**Code Amendment Proposal: Applicability of LGVC Overlay District for Replacement Parking**

# **ATTACHMENT 2**

## **Preliminary On-Site Parking Replacement Plans with Written Summaries**

Re: LU 17-0028 Proposed Code Amendments for Constrained Sites

# Jenike Property

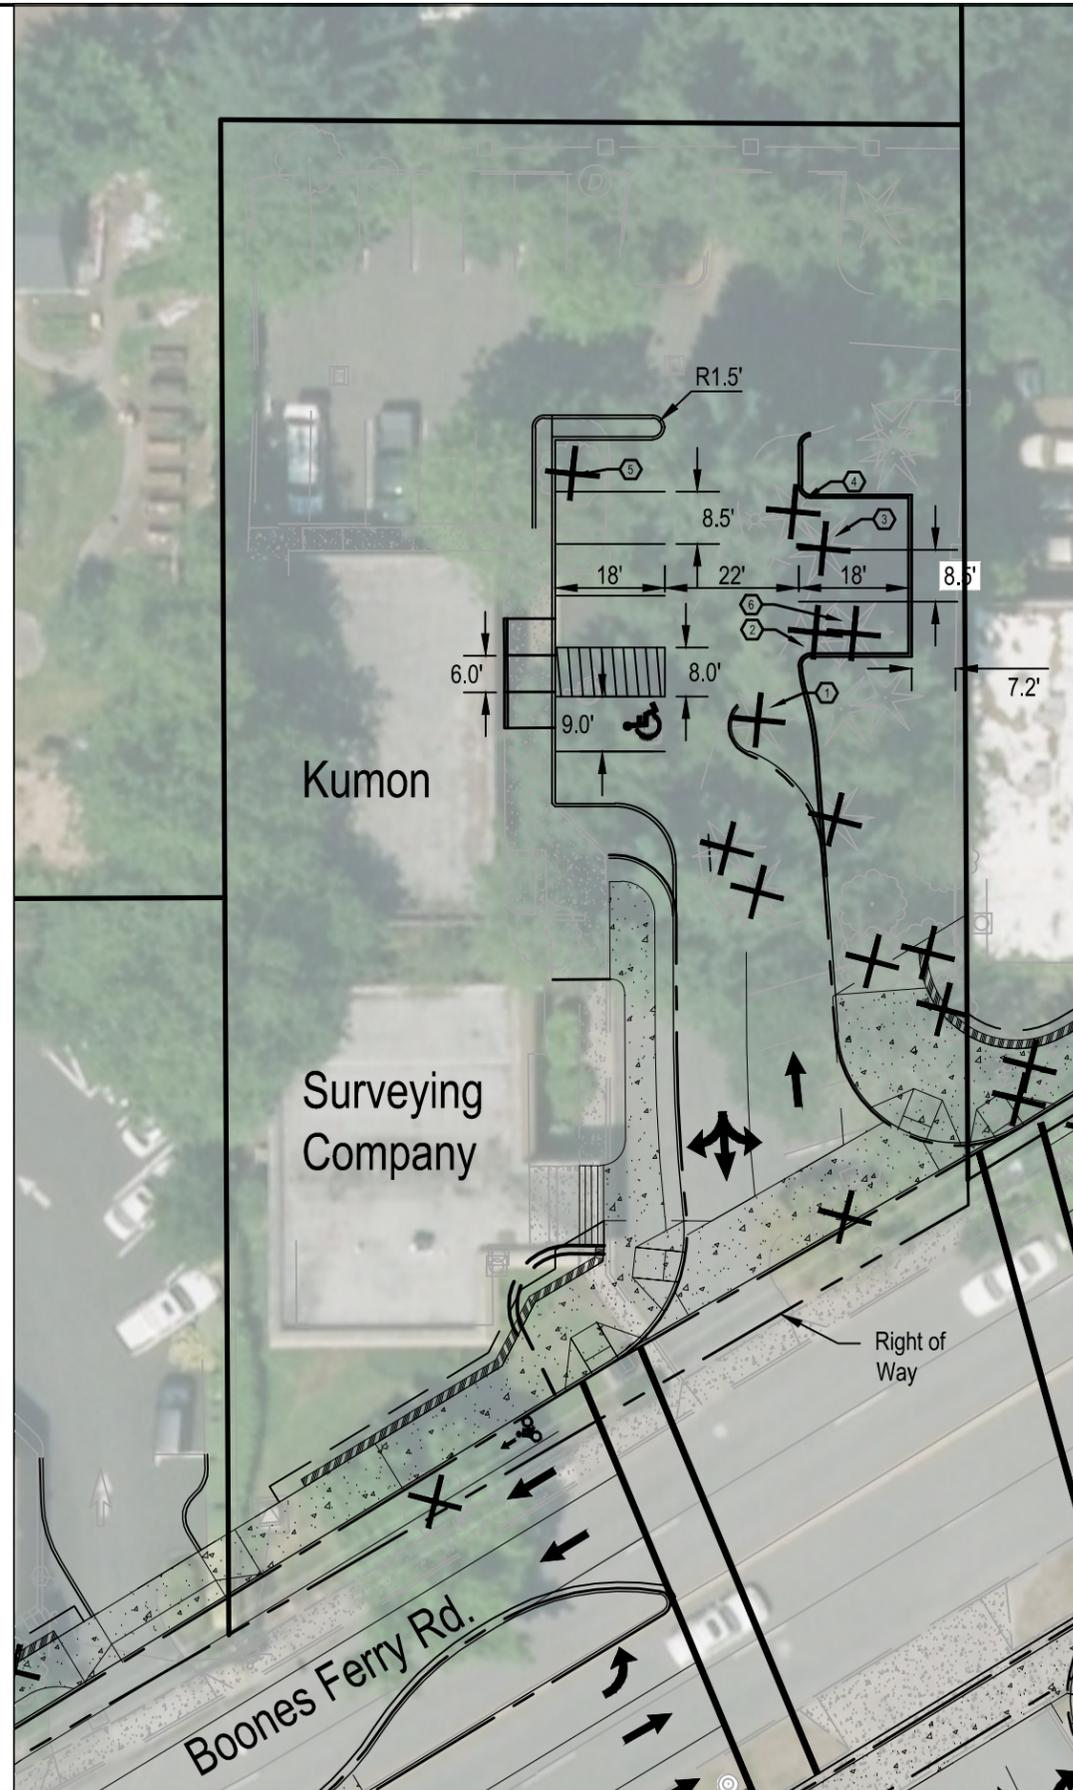
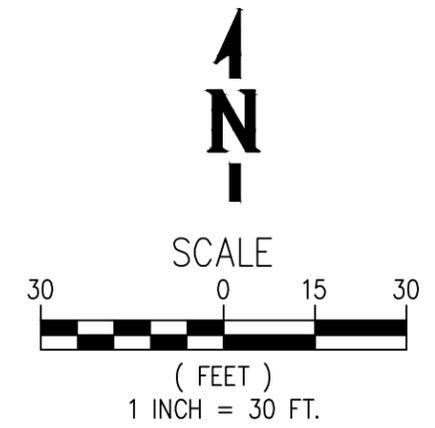
The Jenike property's Preliminary On-Site Parking Replacement Plan has proposed the removal of 6 large trees but in the LGVC Parking Management Plan, page 21, it shows relatively small usage of parking for this site:

With such low usage of the existing parking, is it necessary to remove trees for replacement parking?

Rather than taking away the tree scape of Lake Grove, it would be preferable to focus on offsite public parking options for the Central Zone detailed in the LGVC Parking Management Plan. Could the constrained sites use offsite public parking as part of their replacement parking plan?

Property (**Attachment 2 – pages 10-11**). Ms. Falson specifically notes that the LGVC Parking Management Plan parking occupancy study found that the Jenike Property had low parking rates (**Attachment 3.b**). Staff reviewed the Parking Management occupancy study and found that not all sites that will lose parking to the BFR Project were included as it was a sample study only. Of the ones that were included, three had high occupancy rates (Riccardo's, Gubanc's, and Naomi's Lampshades) and one (Jenike Property) had lower occupancy rates. The parking occupancy study was a snapshot of then-current conditions; the replacement parking will ensure an adequate parking supply for current and future businesses within the District.
